6.6.2 61883-2 timing and synchronization

Figure 6.5—Presentation Time Allocation and Measurement Points

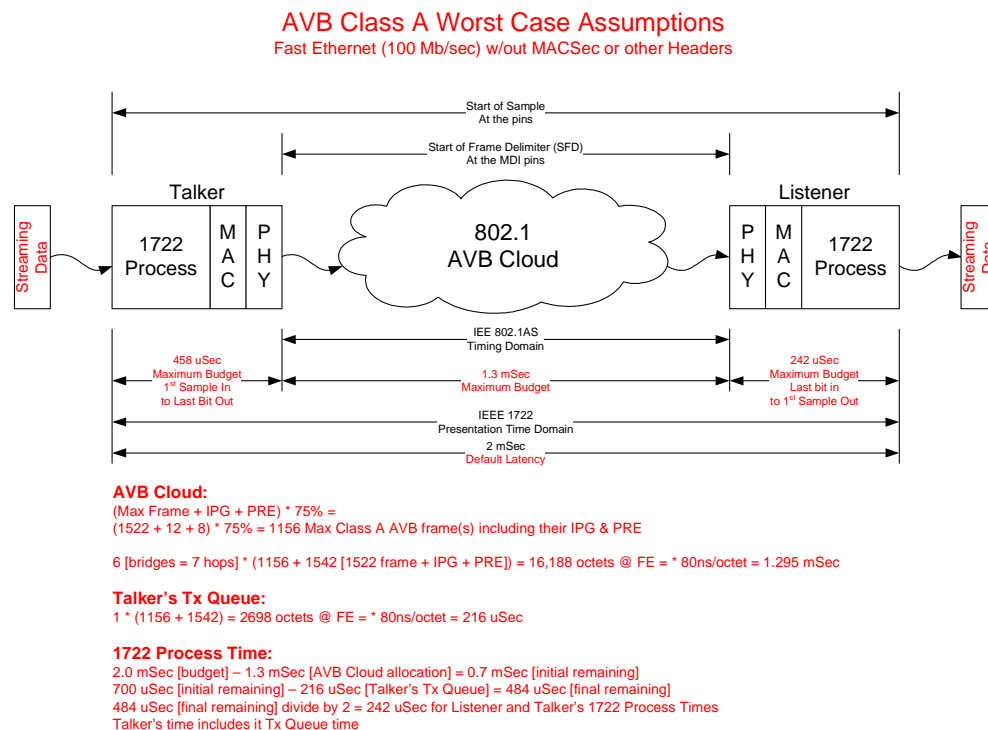
- packet_arrival_time_L ≤ time stamp value <<editors note: **Kevin’s comments: How can a talker guarantee this? Do we need to define how to split this 2 mSec budget up? Need to define the measurement point 1st – Don, Gauart Jones Apple & Rob Silfast Digidesign – editor’s 1st attempt is in Figure 6.56.5 below>>.**
- time stamp value – transmission_delay_limit ≤ packet_arrival_time_F

transmission_delay_limit = default value of 2,000,000 nanoseconds (2 milliseconds) as allocated in Figure 6.56.5 for Class A. <<Editor’s Note: need to add Class B’s budget and figure too – 50 mSec?. Need to define a minimum buffering for all devices – Class A must have 2 mSec & Class B must have 50 mSec. >>

<<Editor’s Note: Presentation time is not Rendering time, i.e., media clocks will need to be filtered. Do we want to spec this? What about the accuracies of the Presentation times? >>
